ARKANSAS NUCLEAR ONE - UNIT NO. 1

## AMENDMENT TO FACILITY OPERATING LICENSE

Amendment No. 31 License No. DPR-51

## ATTACHMENT TO LICENSE AMENDMENT NO. 31 FACILITY OPERATING LICENSE NO. DFR-51 DOCKET NO. 50-313

Figure 2.3-2

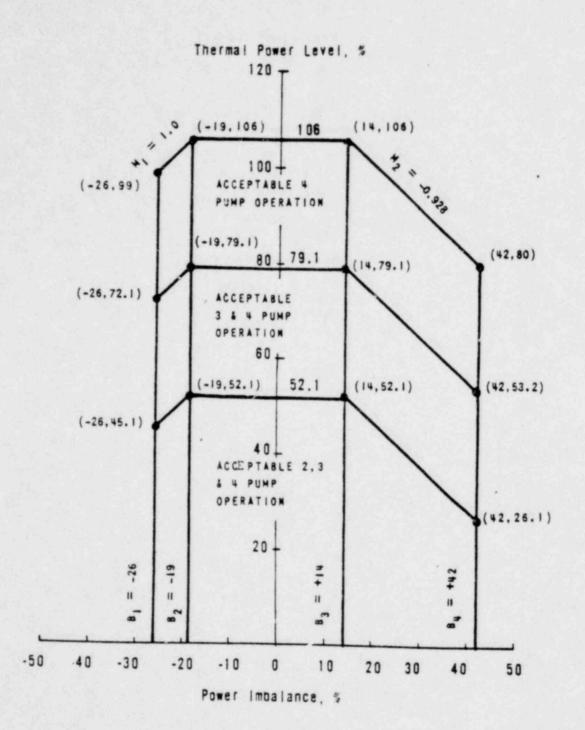
- The protection system maximum allowable setpoints (Figure 2.3-2) shall be reduced 2% in power for each 1% tilt.
  - b. The control rod group and APSR withdrawal limits shall be reduced 2% in power for each 1% tilt in excess of 4.92%.

Figure 3.5.2-34

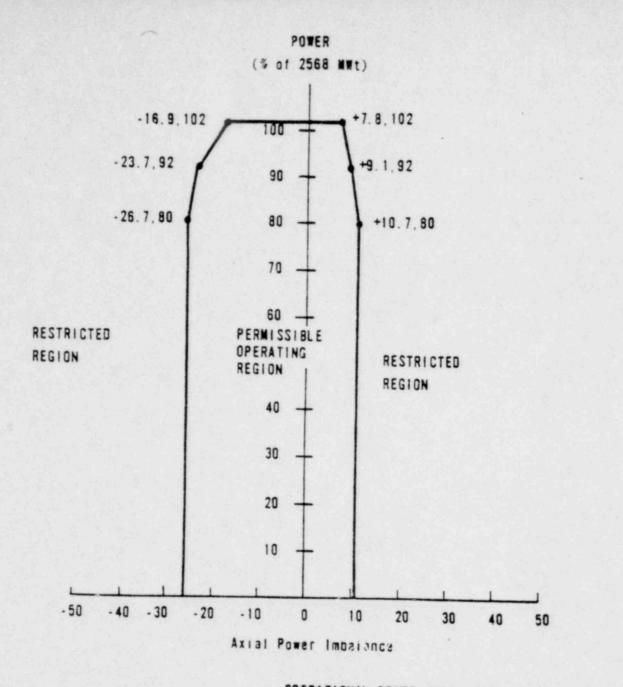
- 3.5.2.6 Reactor Power Imbalance shall be monitored on a frequency not to exceed two hours during power operation above 40 percent rated power. Except for physics tests, imbalance shall be maintained within the envelopes defined by Figures 3.5.2-3A, 3.5.2-3B and 3.5.2-3C. If the imbalance is not within the envelopes defined by Figures 3.5.2-3A, 3.5.2-3B and 3.5.2-3C corrective measures shall be taken to achieve an acceptable imbalance. If an acceptable imbalance is not achieved within four hours, reactor power shall be reduced until imbalance limits are met.

APSR POSITION LIMITS FOR OPERATION FROM 0 TO 100 ± 10 EFPD AND, CYCLE 3 Figure 3.5.2-4A

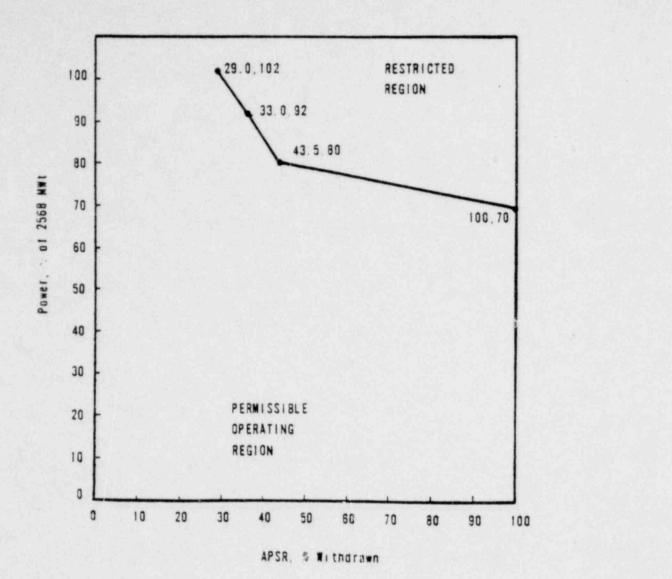
- 3. Except for physics tests or exercising control rods, a) the control rod withdrawal limits are specified on Figures 3.5.2-1A, 3.5.2-1B and 3.5.2-1C for four pump operation and on Figures 3.5.2-2A, 3.5.2-2B and 3.5.2-2C for three or two pump operation and b) the axial power shaping control rod withdrawal limits are specified on Figures 3.5.2-4A, 3.5.2-4B and 3.5.2-4C. If any of these control rod position limits are exceeded, corrective measures shall be taken immediately to achieve an acceptable control rod position. Acceptable control rod positions shall be attained within four hours.
